**From:** O'Brien, Robin  
**Sent:** Monday, December 16, 2013 4:58 PM  
**To:** 'leslee@fortmyersbeachfl.gov'  
**Cc:** Grady, Beverly; jwr@embarqmail.com; 'Dean Martin (dean@tdmconsulting.com)'  
**Subject:** Rusty's/Shipwreck - Special Exception adding North Parcel of Shipwreck; Amended Narrative amending existing variances already filed; Addendum for Additional Relief Narrative for Special Exception application REVISED for future retail(7624958\_2).DOCX; Richard -(7765742\_1).DOCX; Addendum to Narrative for Rusty\_s\_Shipwreck variance of 10\_31\_13(7878549\_1).DOCX  
**Attachments:**

REZ2013-0002 Supplement PH-A

NARRATIVE STATEMENT FOR SPECIAL EXCEPTION REQUEST  
REVISED DECEMBER 2013 TO ADD "PARKING, SHARED AND PERMANENT" TO  
NORTH PARCEL

Variance No. 5

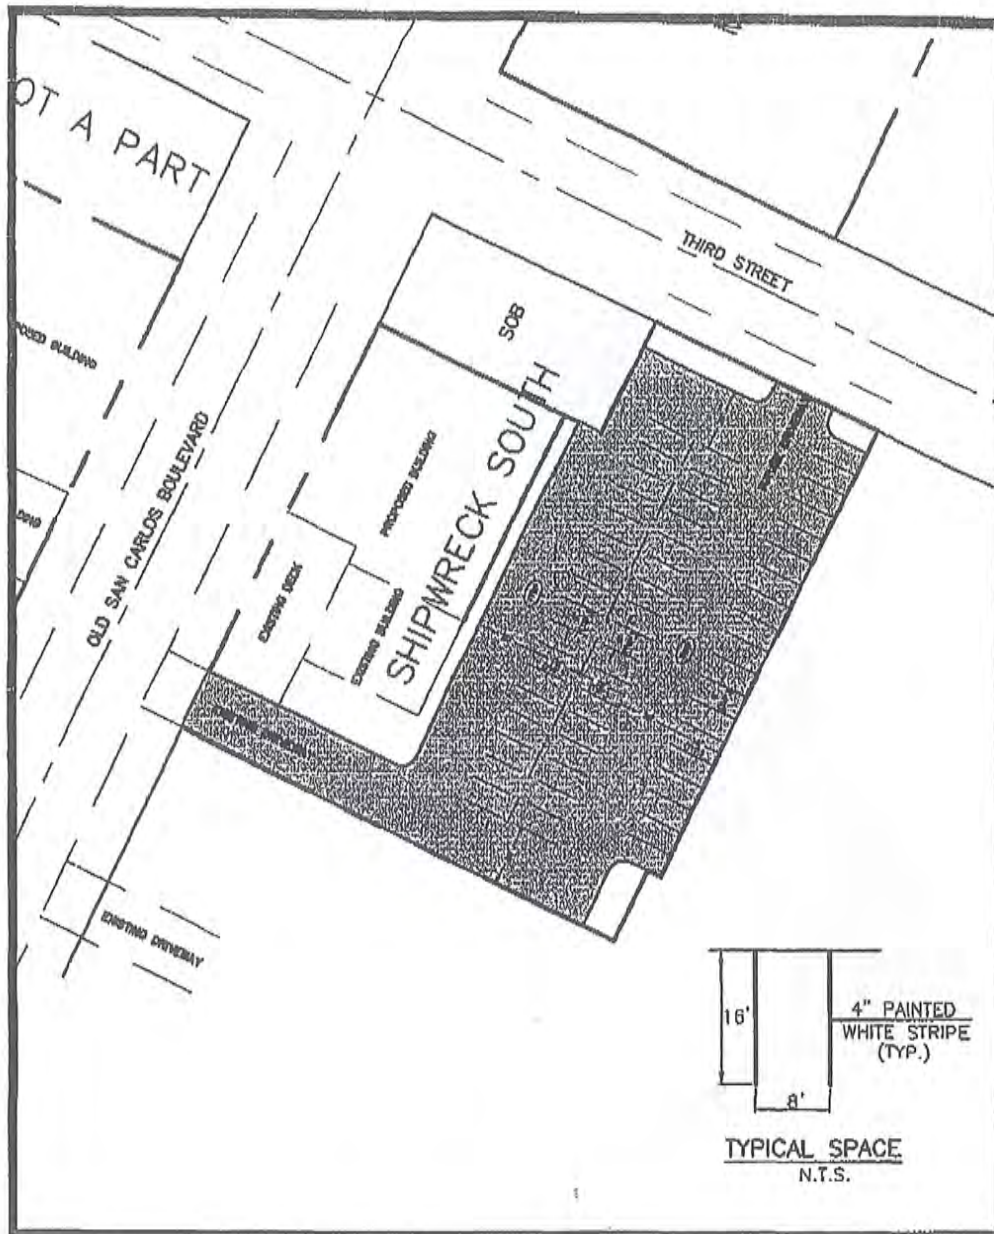
A variance from Section 34-622(a) and Section 34-3131 to eliminate visibility triangle for the access on Third Street.

Justification. Due to improvements within the right-of-way on Third Street that have been approved by the Town, an on-site visibility triangle provides no benefit and is not necessary for ingress or egress to the parking area. A visibility triangle will not provide increased visibility in this location.

**EXHIBIT A**  
**SHIPWRECK NORTH**  
**PARKING LAYOUT**  
 JOHN RICHARD  
 FORT MYERS BEACH, FL

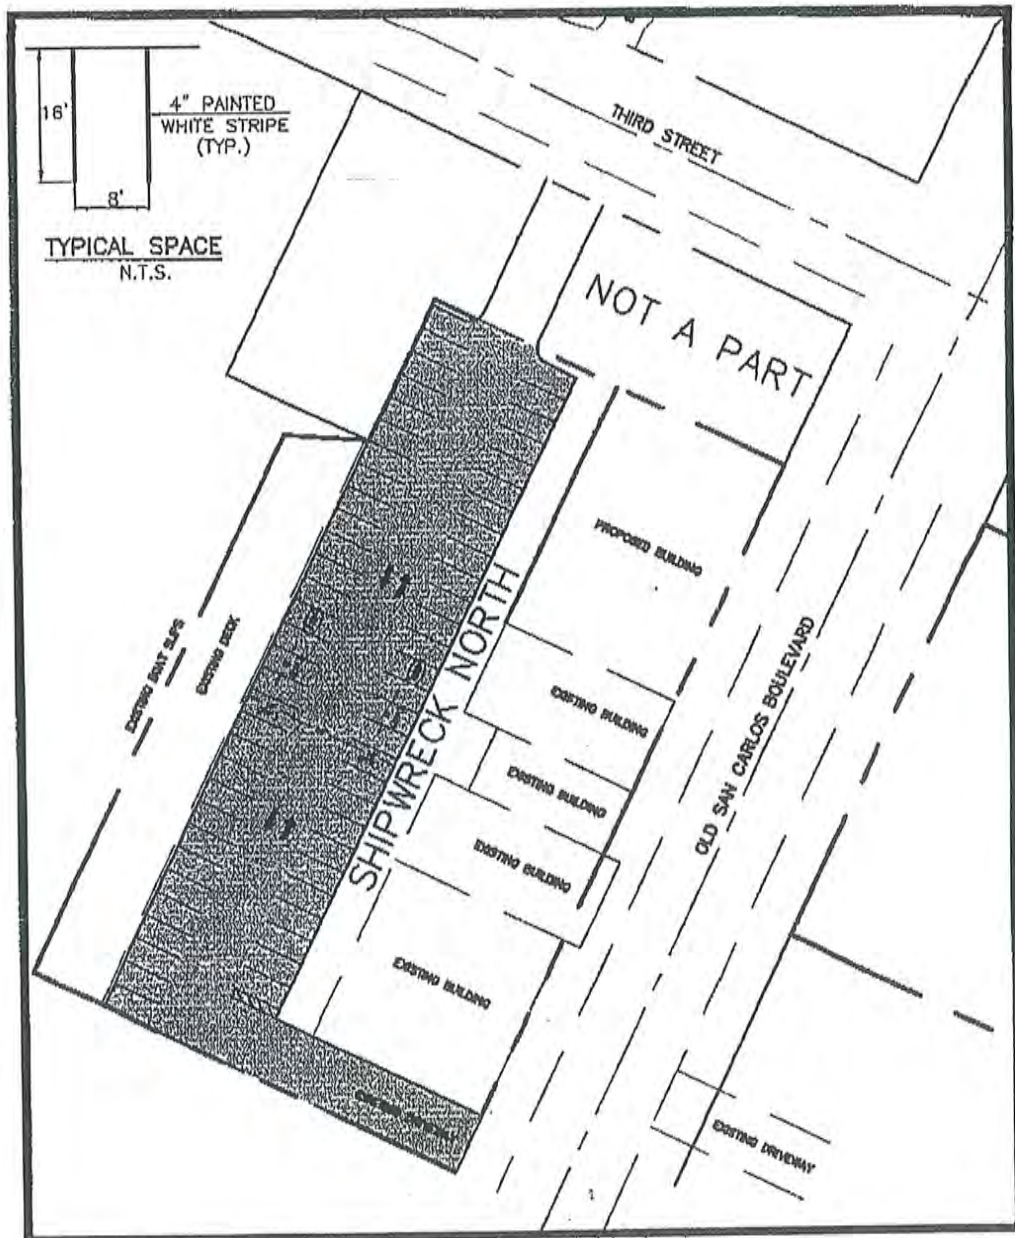
*parking  
 dimension  
 variance*

**EXHIBIT A**  
**SHIPWRECK SOUTH**  
**VALET PARKING EXHIBIT**

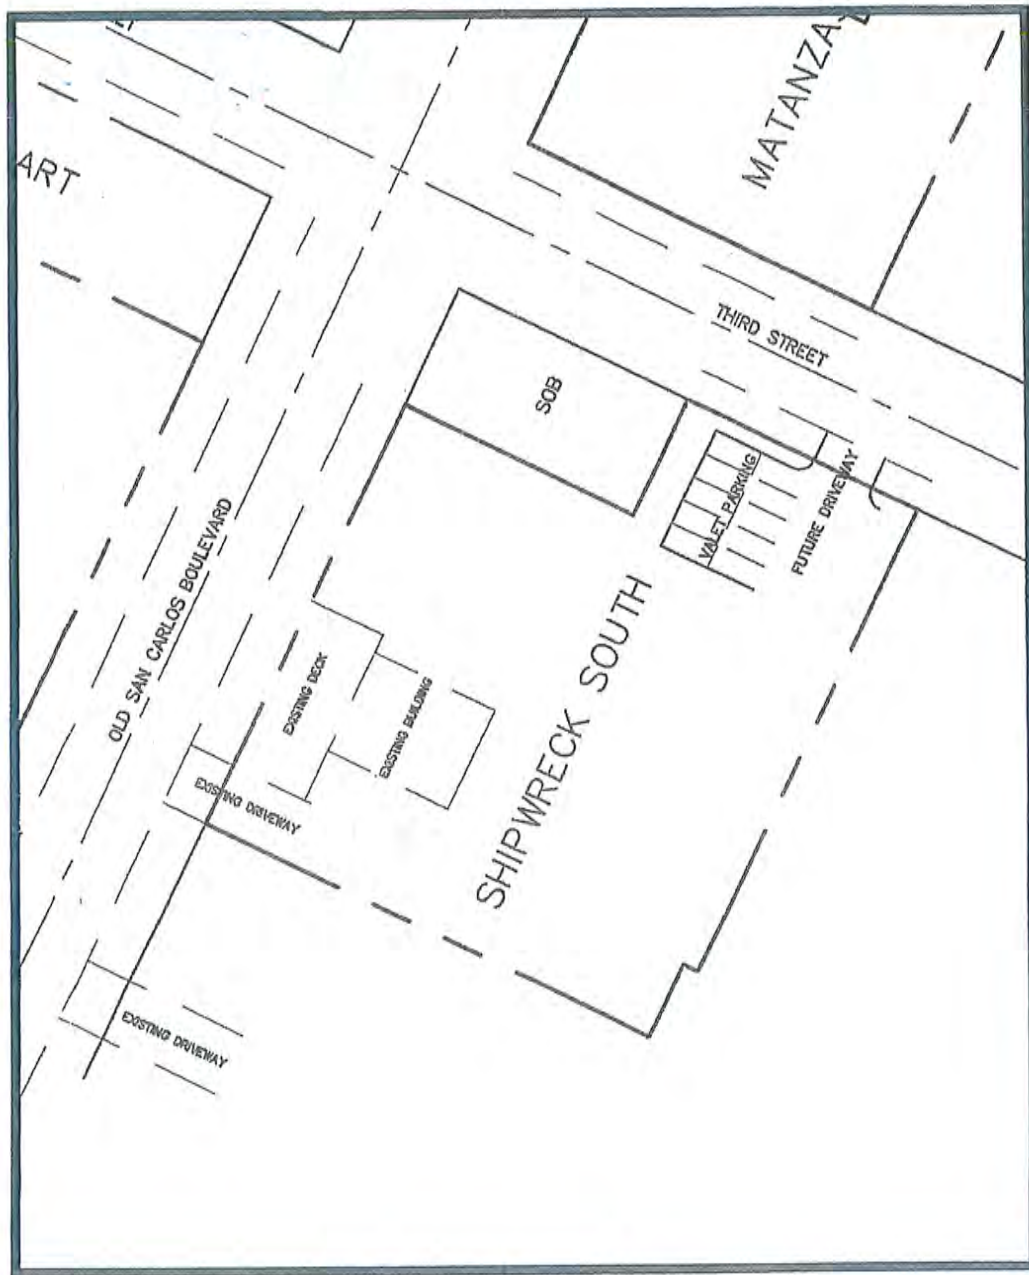
Valet parking is also planned for both the North and South Parcels of Shipwreck. It is an appropriate mechanism to maximize parking which is consistent with the Downtown Report, prior studies and plans reviewed and adopted by the Town and valet parking has been approved in other locations in the Town.

**EXHIBIT A**  
**SHIPWRECK NORTH**  
**PERMANENT SHARED PARKING EXHIBIT-CURRENT**  
 JOHN RICHARD  
 FORT MYERS BEACH, FL  
 SOURCE: TDM, 12/13

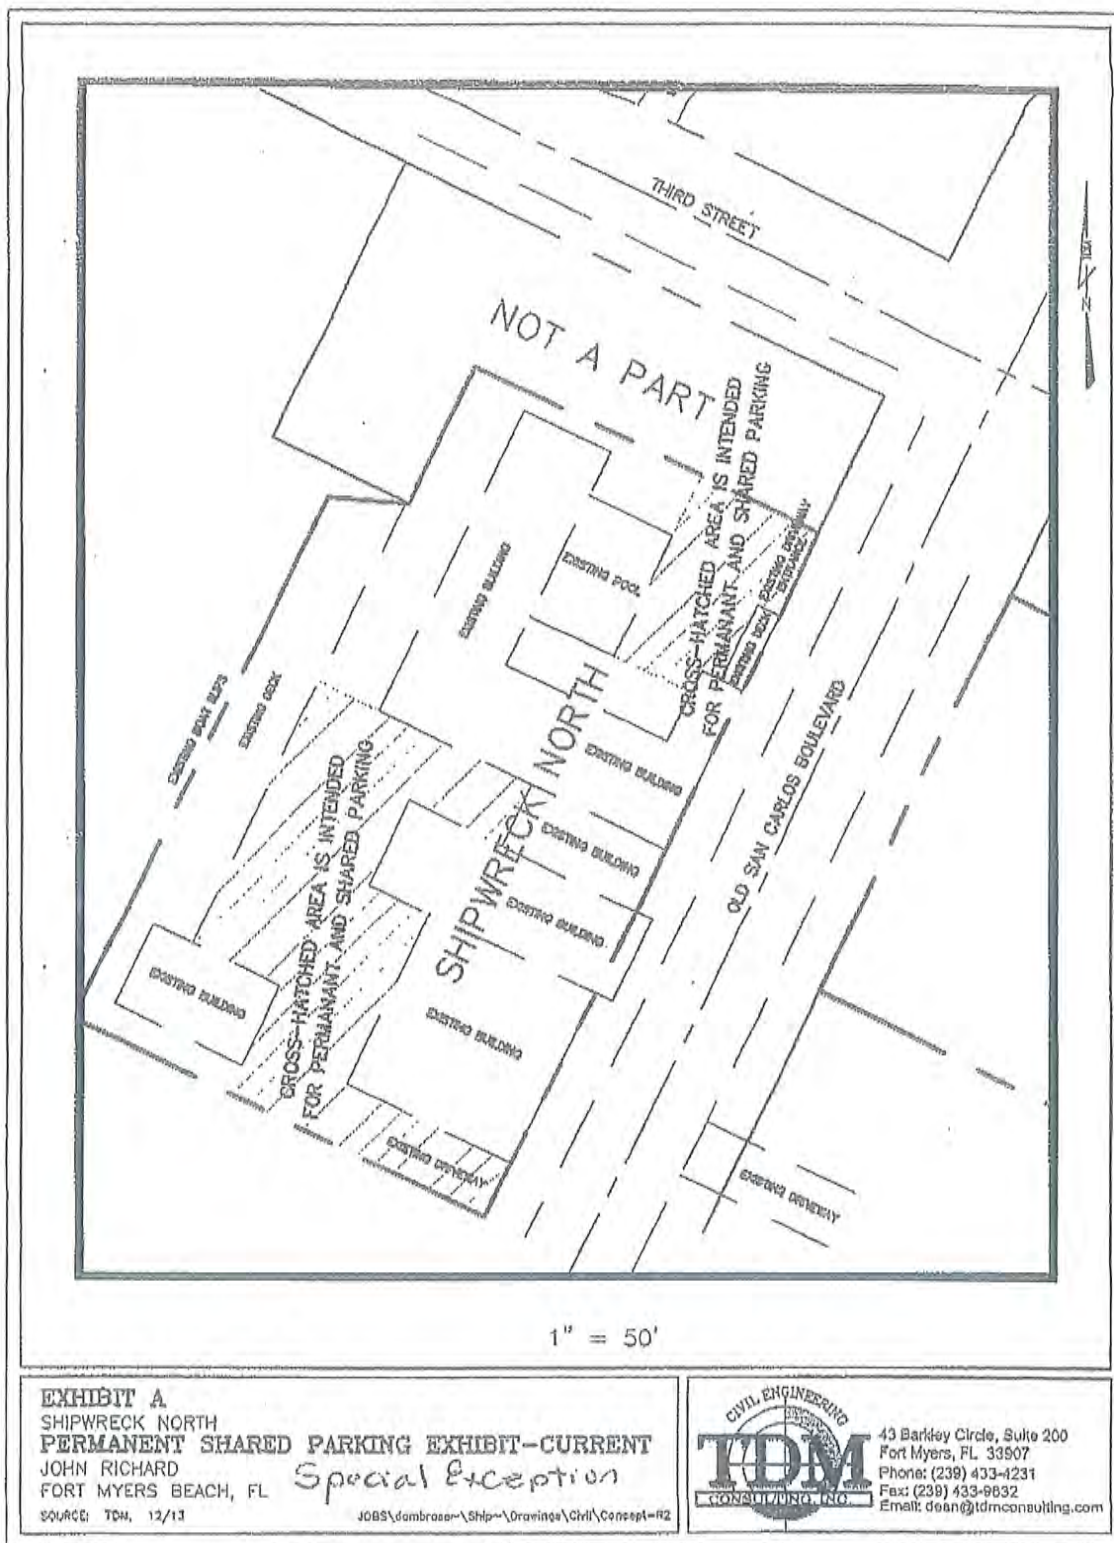
*Special Exception*

**EXHIBIT A**  
**SHIPWRECK NORTH**  
**PERMANENT SHARED PARKING EXHIBIT-FUTURE**  
**JOHN RICHARD**  
**FORT MYERS BEACH, FL**

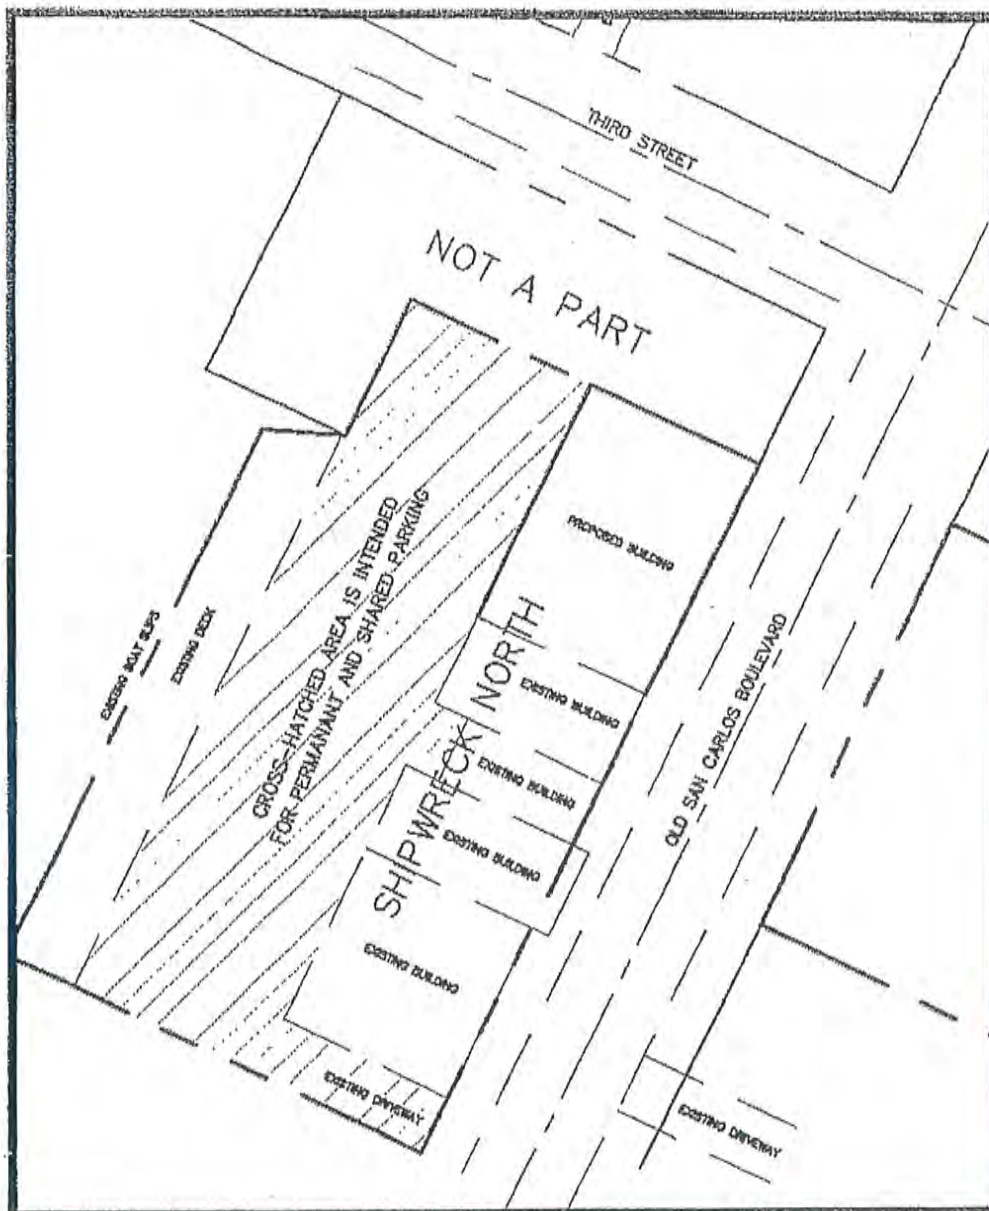
*Special Exception*

**EXHIBIT A**  
**SHIPWRECK NORTH**  
**PERMANENT SHARED PARKING EXHIBIT-FUTURE**  
**JOHN RICHARD**  
**FORT MYERS BEACH, FL**  
*Special Exception*

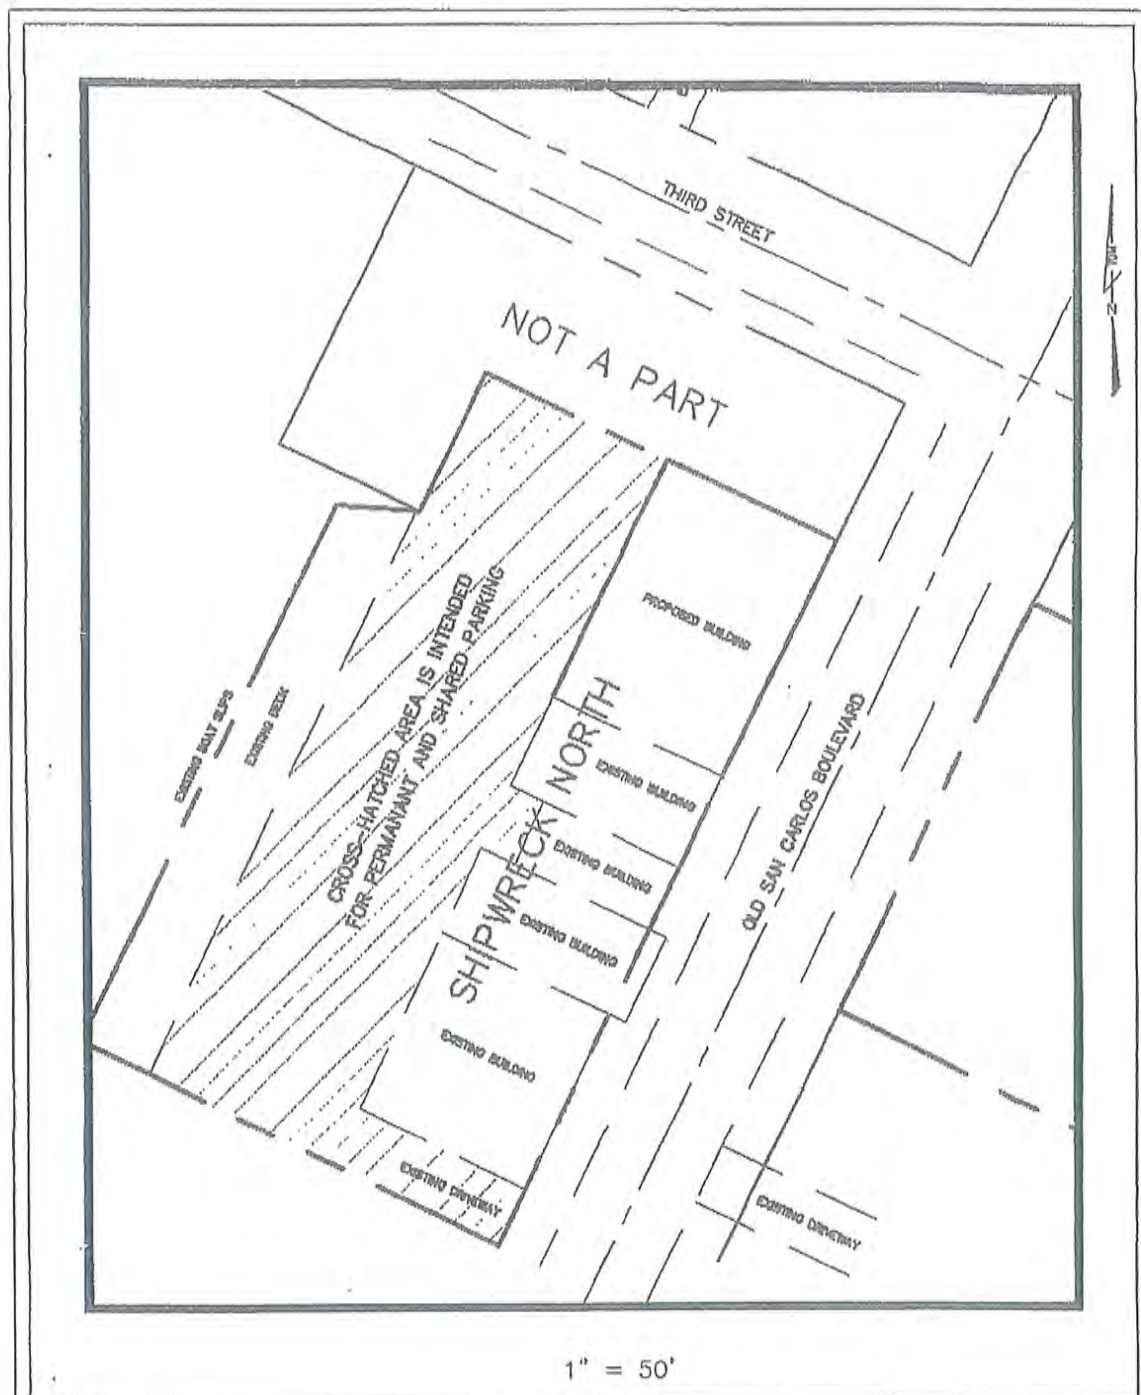
"Parking, shared and permanent" is an appropriate use for the North Parcel, consistent with the Comprehensive Plan and the Land Development Code. The draft Downtown Development Agency and Review of Redevelopment and Activities Report ("Downtown Report") was presented to Town Council on November 18, 2013 and it supports the holistic approach to redevelopment and includes the following goal:
